Charlotte Department of Transportation

Memorandum

Subject: Rezoning Petition 15-062: Approximately 20.9 acres located at the intersection of NC Music Factory Boulevard and Hamilton Street generally surrounded by Interstate 77, West Brookshire Freeway, and Seaboard Coast Line Railroad

Figure 1

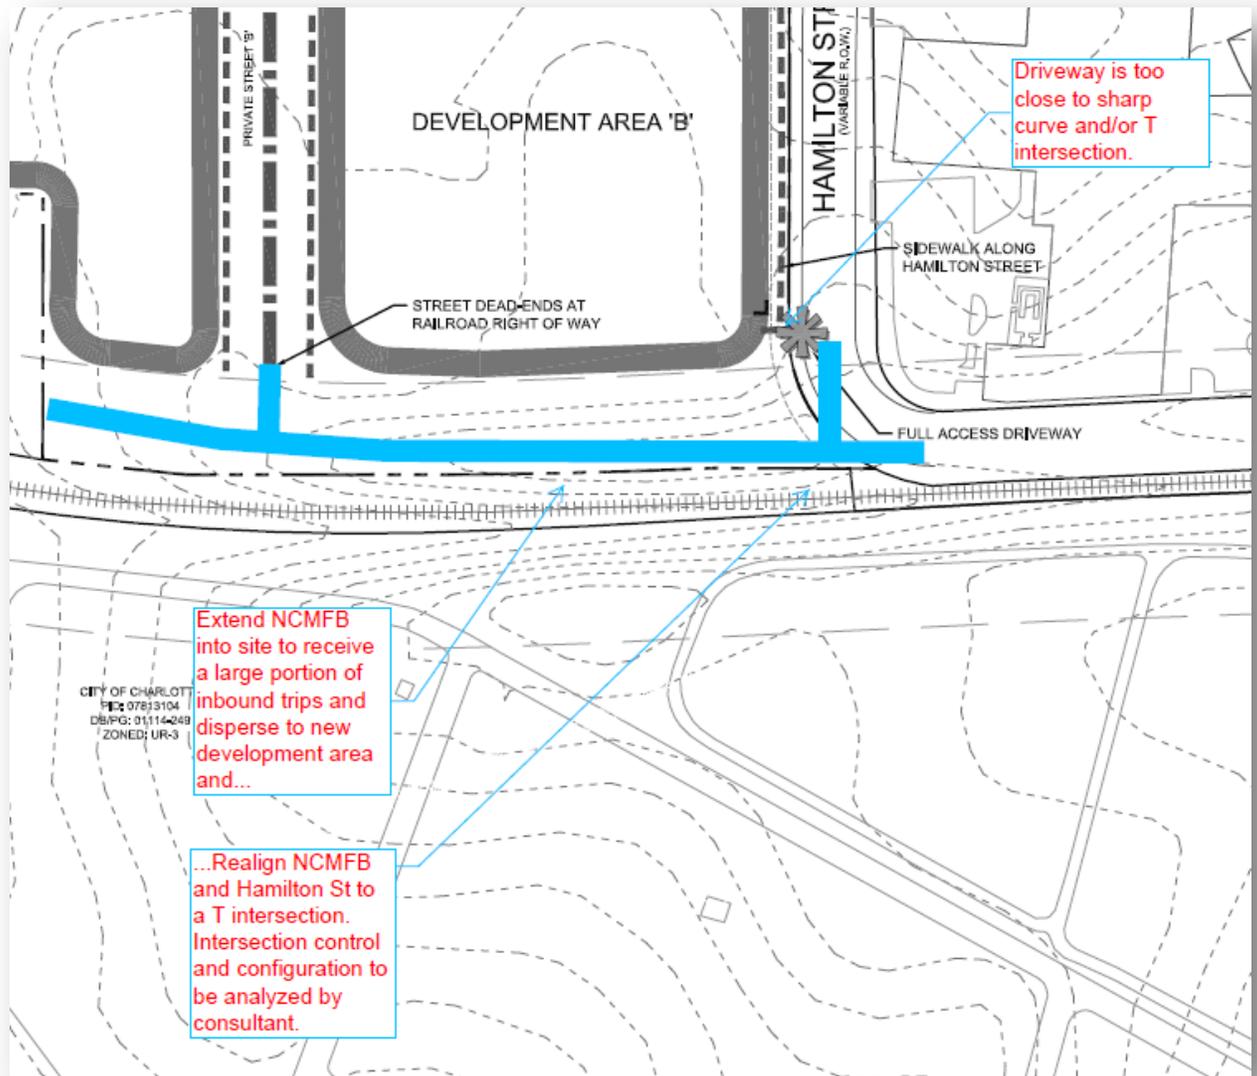
1. CDOT requests the petitioner investigate extending North Carolina Music Factory Boulevard (NCMFB) into the new development area to receive a large portion of vehicular trips to the office and parking areas. By doing this, the intersection of NCMFB and Hamilton Street becomes realigned to a T-intersection configuration. The petitioner should analyze this T-intersection and make recommendations as to the appropriate traffic control device (e.g. stop signs or signal). See Figure 1 below.
